**INLAND WETLANDS AGENCY
REGULAR MEETING AGENDA
MONDAY, OCTOBER 18, 2021, 7:00 P.M.
TOWN HALL ANNEX MEETING ROOM, 57 MAIN STREET, ELLINGTON, CT**

1. William & Maureen Keohane, owner/applicant, request for a permit to conduct regulated activity for the demolition and reconstruction of a single family home and associated site improvements at 2 East Shore Road, APN 149-093-0000.

From: Dana Steele <dstele@jrrusso.com>
Sent: Tuesday, October 12, 2021 11:48 AM
To: John Colonese
Cc: Lisa Houlihan; Barbra Galovich
Subject: IW202111 - Keohane, 2 East Shore Rd

I've reviewed the plans and calculations for IW202111, 2 East Shore Rd prepared by Design Professionals including 3 plan sheets dated 9/10/21 and a Project Narrative with stormwater calculations dated 9/1/21. My comments are as follows:

FE-1 Level Spreader Design

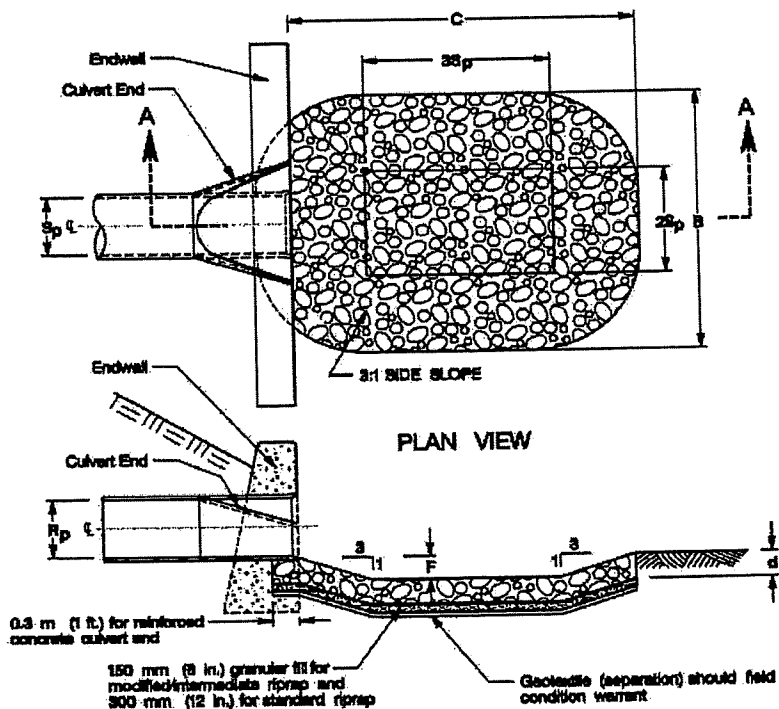
1. The "level spreader design" sizing the CT E&S Guidelines assumes a level apron but the proposed riprap apron is on a steep slope. I recommend grouting the riprap with concrete to protect against erosion and extending the apron beyond the toe of the slope while minimizing disturbance of established vegetation.

C-DAT1 Sheet 1 of 1	CATCHMENT AREA MAPS	NO.	DATE	REVISIONS	BY
	SCALE: 1" = 40'

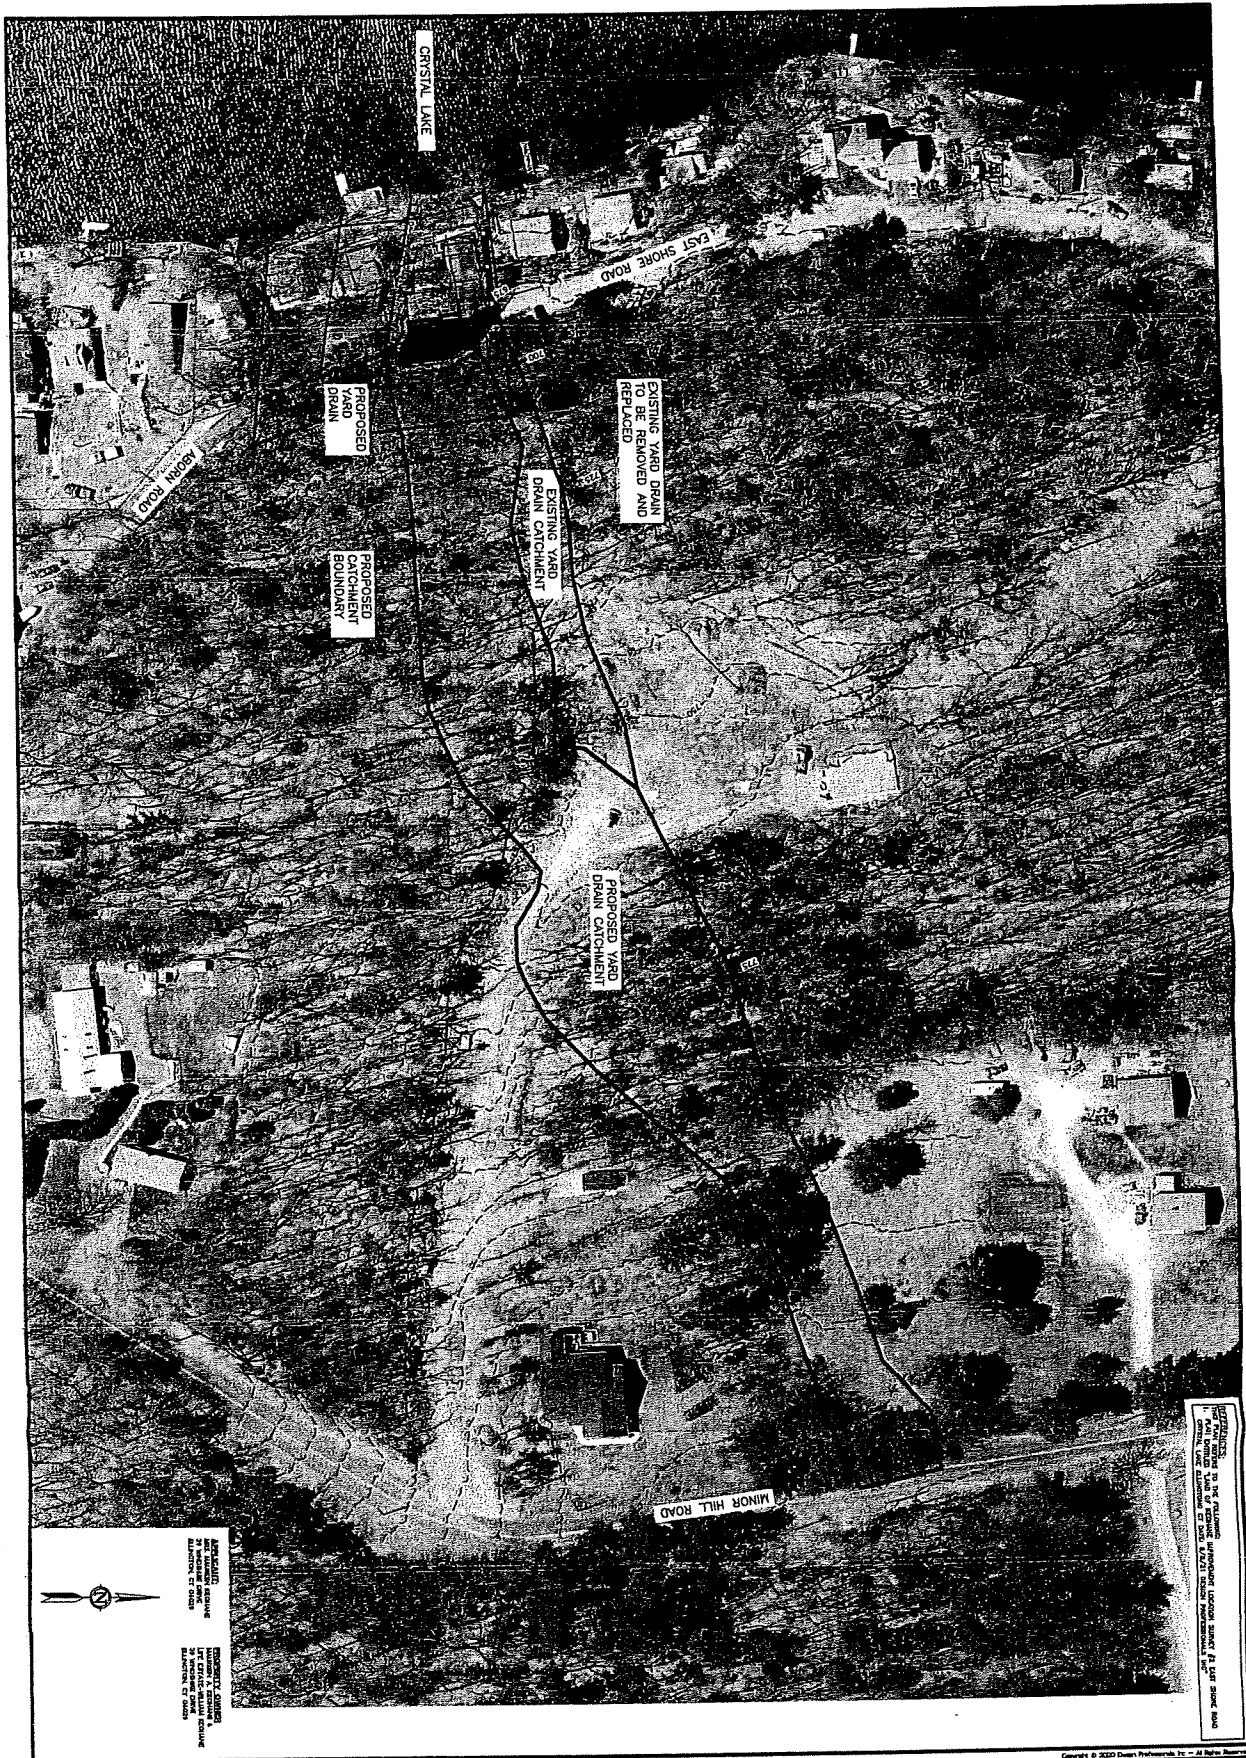
2. The drainage areas to YD-1 and YD-2 are not consistent with the grading plan. The watershed area appears to be more evenly distributed between the two structure than what is calculated. This may impact the required size of the riser and outlet pipe from YD-1. The watershed analysis should also take into consideration the recent development of the upstream abutter. If you provide the engineer with a copy of the as-built that would be helpful.

SCALE: 1" = 10'
 SHEET 1 OF 3
C-SP1

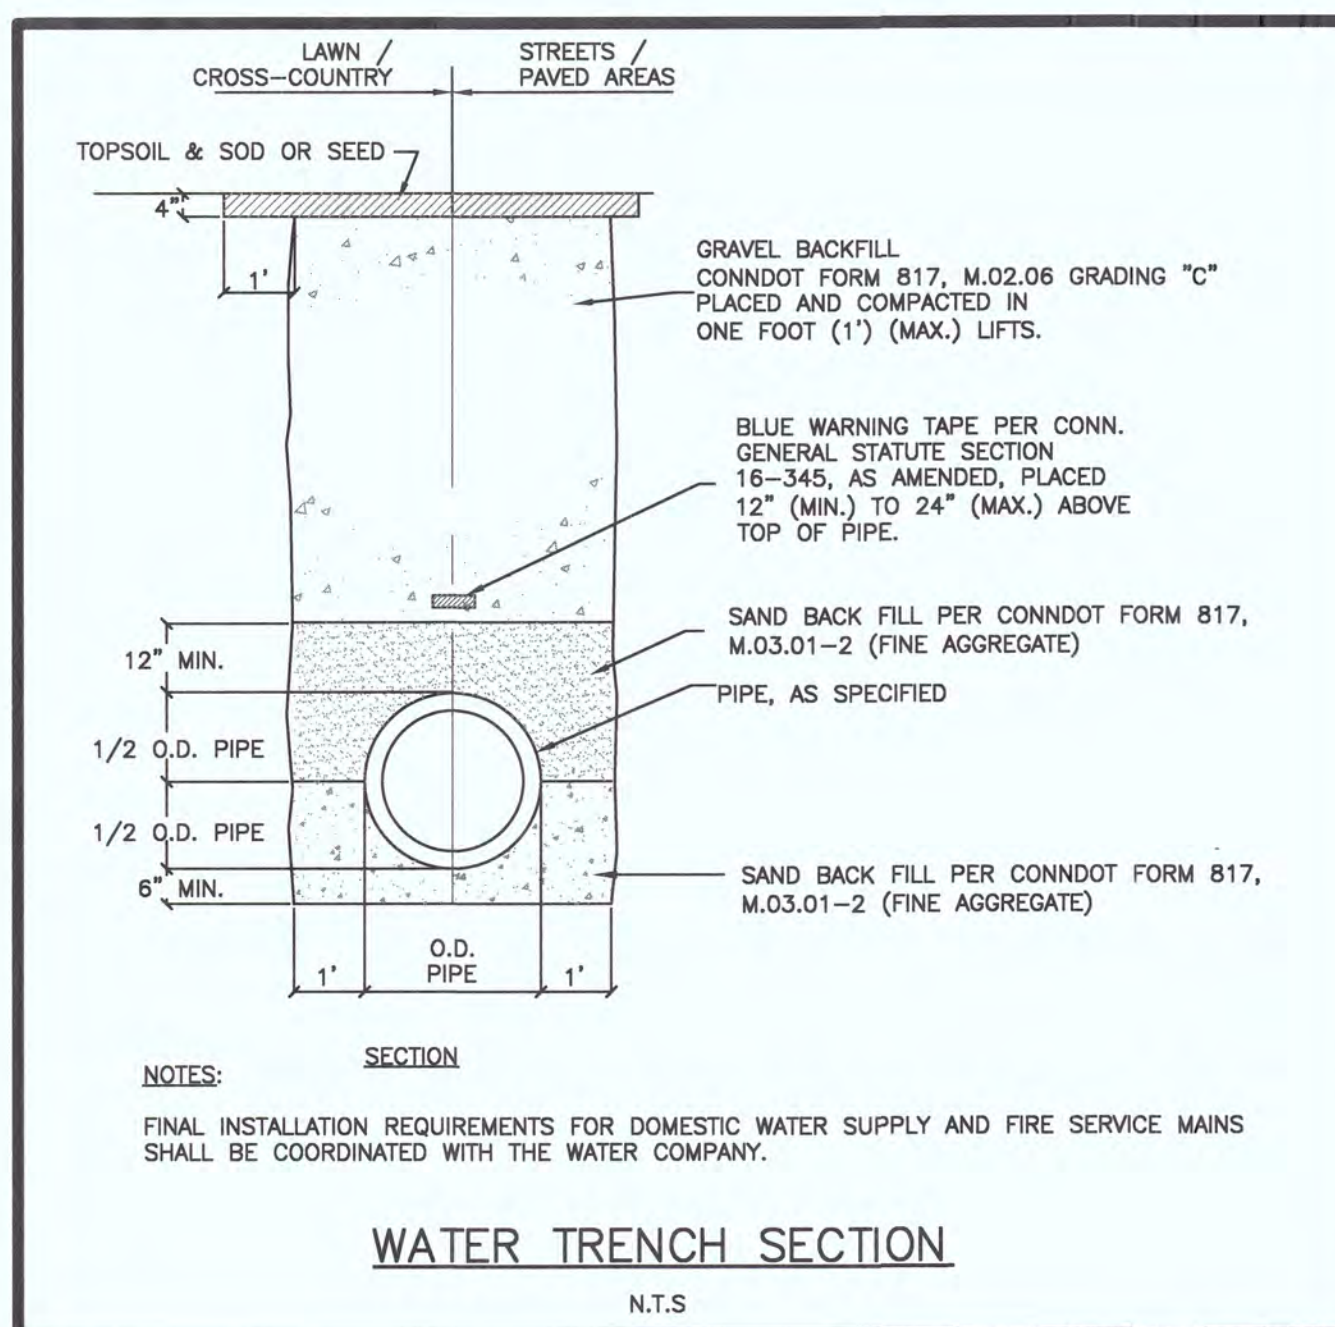
3. The detail references on sheet C-SP1 refer to incorrect sheets or sheets not included in the plan set. These references should be updated.
4. The plans should include a line type and symbols legend.
